SUBJECT: NuScale Power, LLC Response to NRC Request for Additional Information No. 317 (eRAI No. 9254) on the NuScale Design Certification Application

eRAI No.: 9254

NRC Question No.: 03.07.02-33

Figure 1: Plan View Dimensions of the Exterior Shear Walls

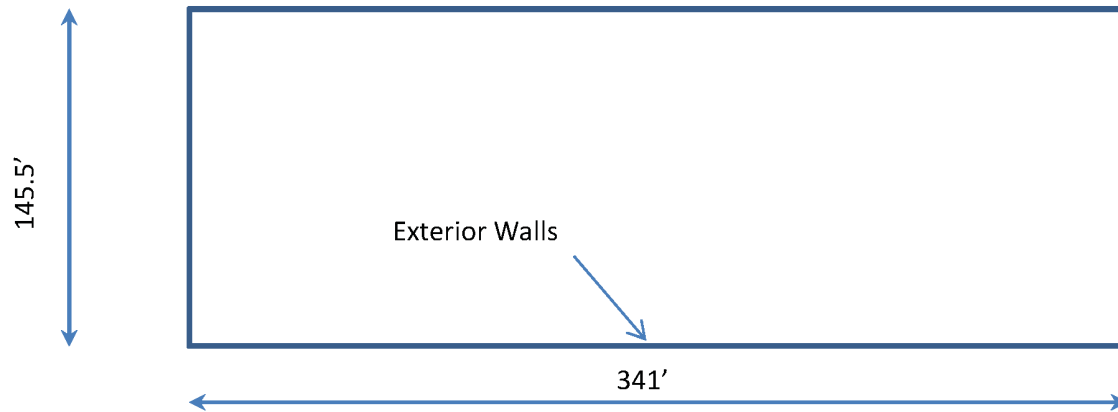
The staff reviewed the applicant's approach to addressing accidental torsion by increasing the horizontal element forces by 5% in lieu of increasing the eccentricity by 5%. The staff is unable to determine the validity of the applicant's approach that involves a uniform increase of horizontal element forces by 5% in contrast to the DSRS methodology that involves an increase of 5% torsional eccentricity on a floor level. DSRS 3.7.2, Acceptance Criteria II.11 specifies that, to account for accidental torsion, an additional eccentricity of plus or minus 5% of the maximum building dimension should be assumed for both horizontal directions and that the magnitude and location of the two eccentricities are determined separately for each floor elevation. The staff also notes that similar guidance on accounting for accidental torsion is available in industry standards; e.g., ASCE 4-16 specifies that the effect of accidental torsion be calculated at each floor level by static analysis assuming a torsional moment equal to the product of the story shear and 5% of the plan dimension perpendicular to the direction of motion of the structure at that level.

The staff finds that the applicant has not demonstrated that an eccentricity of 5% of the building

dimension is equivalent to a 5% increase in the elemental horizontal forces. Therefore, the applicant is requested to provide additional information that provides the requested technical justification to demonstrate the equivalency to the DSRS methodology or conservatism in the method used by the applicant. Compliance with the DSRS is not a requirement; however, the applicant should identify differences between the analytical methods used for its design and the DSRS acceptance criteria and evaluate the technical acceptability of its methods. The applicant may choose to use a smaller model to illustrate the comparison of the results from the two approaches.

The lateral load-resisting system of the reactor building is the reinforced concrete shear walls. The most efficient shear walls to resist the torsional effects are the exterior walls along the perimeter of the building. Only these exterior walls are considered to resist accidental torsion; the effects of the interior walls are conservatively ignored. This reduces the problem to a closed, thin-wall section subject to torsional effects. The additional shear in the walls is calculated and compared with direct shear due to direct base shear to show technical justification that the 5% amplification factor of the seismic demand is conservatively equivalent to the 5% mass offset method for addressing accidental torsion.

Shear stresses in the exterior walls (plan view shown in Figure 1) due to both direct base shear and accidental torsion are calculated. Comparing the difference between them will show the significance of accidental torsion in the seismic demands.

Direct base shear creates in-plane shear on the 5 foot thick exterior walls that are parallel to the base shear. Due to the rigid diaphragms in the reactor building, under direct shear, all exterior walls will experience the same shear stress, to satisfy deformation compatibility.

For shear due to accidental torsion, a closed, thin-walled section subject to torsion resists the applied shear in the form of in-plane shear flow in the exterior walls.

As shown by these calculations, the effect of accidental torsion is 5% of the effect of direct base shear. This, in turn, indicates that, to equivalently account for accidental torsion effects, seismic demands can be increased by 5%.
